Work Order ID 99387

Item ID: D205-634-141 Accept *N9000040100* Setup Start *NS1*
 Revision ID: Stop *NS2*
 Item Name: Replacement Skidtube
 Start Date: 4/04/13 Start Qty: 1.00 *1* Cust Item ID:
 Required Date: 4/19/13 Req'd Qty: 1.00 *1* Customer:
 Reference:

DRAWING NO. D2580	TITLE 205 SKIDTUBE ASSEMBLY	REV. E	DART AEROSPACE LTD ENGINEERING ORDER	D.E.O. NO. D2580-E-1	SHEET NO. SHEET 1 OF 1	SCALE NTS
DRAWN <i>UP</i>	CHECKED <i>ASS</i>	MFG. APPR. <i>EC</i>	APPROVED <i>#</i>	DE APPR. <i>#</i>		
DATE 11.12.13	DATE 11.12.13	DATE 11.12.13	DATE 11.12.13	DATE 11.12.13

CHANGE ALL C'BORED WELDED CROSSBOLT SPACERS TO SWAGED SPACERS

SECTION B-B, F-F, I-I
NOT TO SCALE

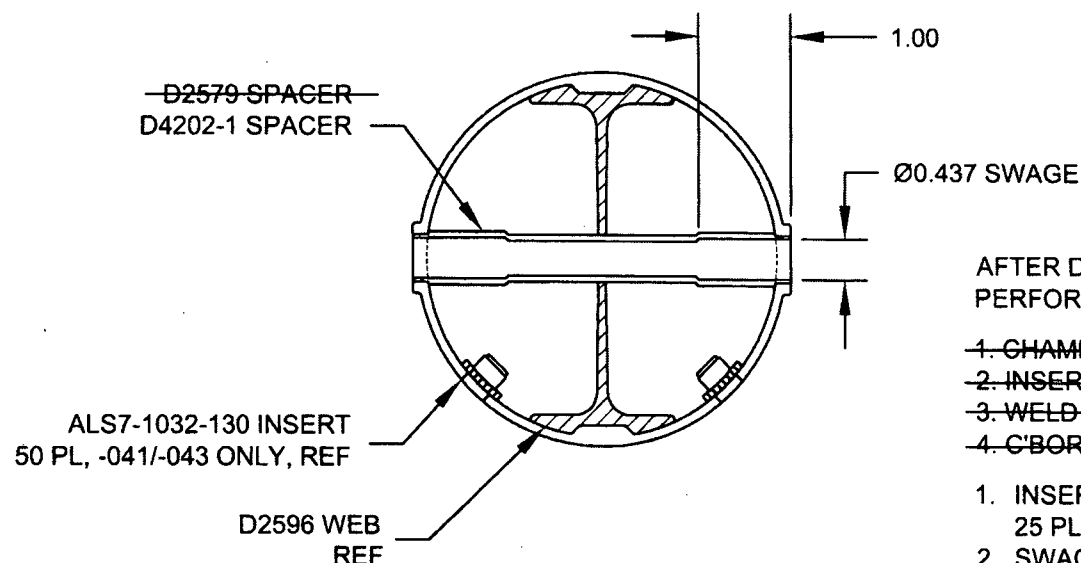
SECTION B-B, SECTION F-F, & SECTION I-I ARE AMENDED AS FOLLOWS
FOR ALL HOLES THAT WERE ORIGINALLY C'BORED:

*** FOR -045 SKIDTUBE ONLY:**

WELD 4X D2579 SPACERS PER DWG
IN LOCATIONS MARKED "NO C'BORE".
REF SHEET 4 OF DWG.

AFTER DRILLING AND BENDING ASSEMBLY
PERFORM THE FOLLOWING FOR Ø0.508 HOLES ONLY:

1. CHAMFER HOLE 0.050 X 45°
2. INSERT D2579 SPACER (20 PLACES)
3. WELD INTO PLACE AND GRIND FLUSH
4. C'BORE D2579 SPACER TO Ø0.437 X 1.00 DEEP

1. INSERT D4202-1 SPACER, 20 PL (-041) OR 20 PL (-045) OR 25 PL (-047)
2. SWAGE TO Ø0.437 X 1.00 DEEP PER QSI 002
3. TRIM / GRIND FLUSH PER QSI 002
